Case No. 16DEVPLAN1022

Albany Avenue Building Project

**Louisville Metro Board of Zoning Adjustment Public
Hearing**

June 6, 2016

Site Photos-Subject Property

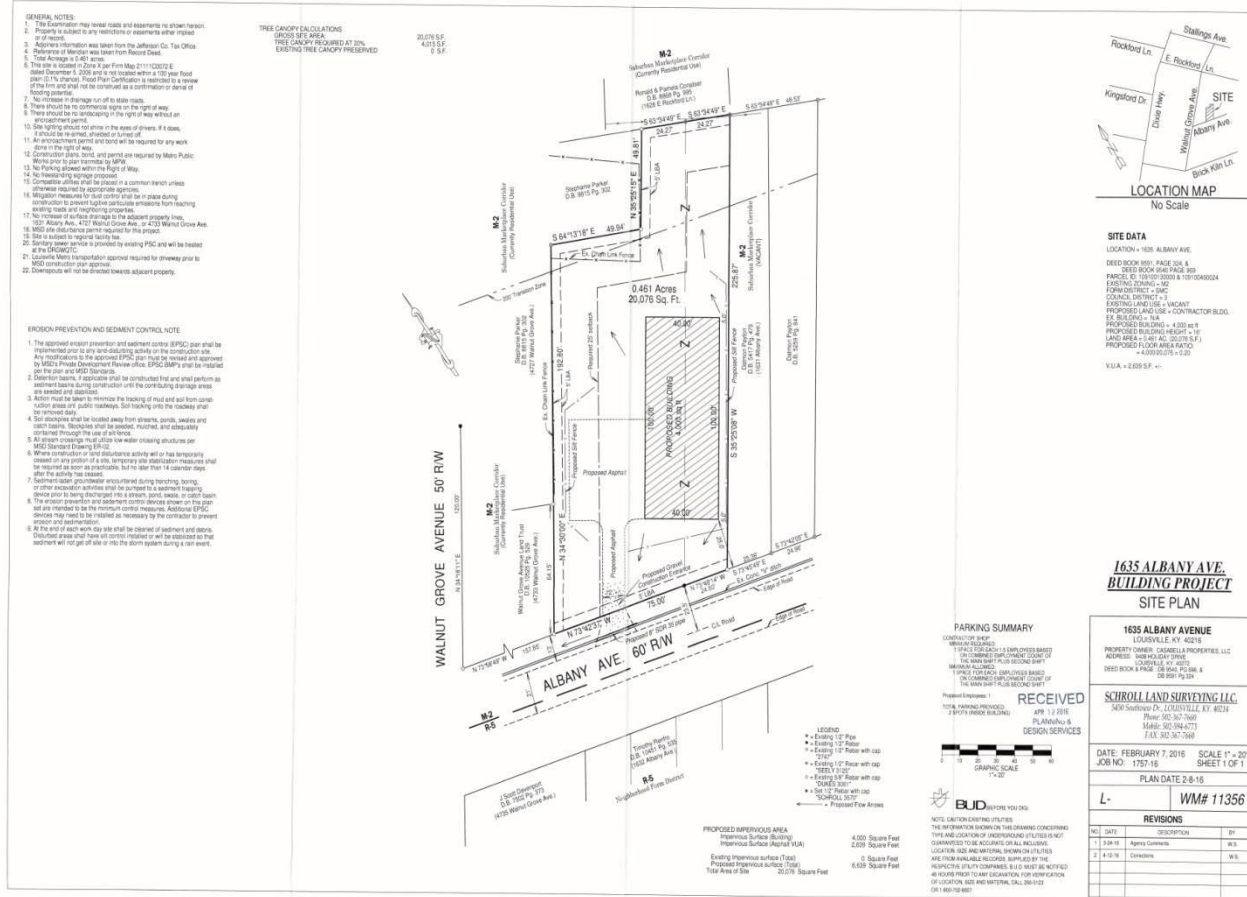
Looking along the subject site frontage along Albany Ave., the applicant is requesting a waiver from having to provide a sidewalk. (Sidewalk waiver and waiver #3)

Looking from the rear of the subject site towards Albany Ave. The Transition zone waiver is the result of the homes shown directly across Albany Ave. (Waiver #2)
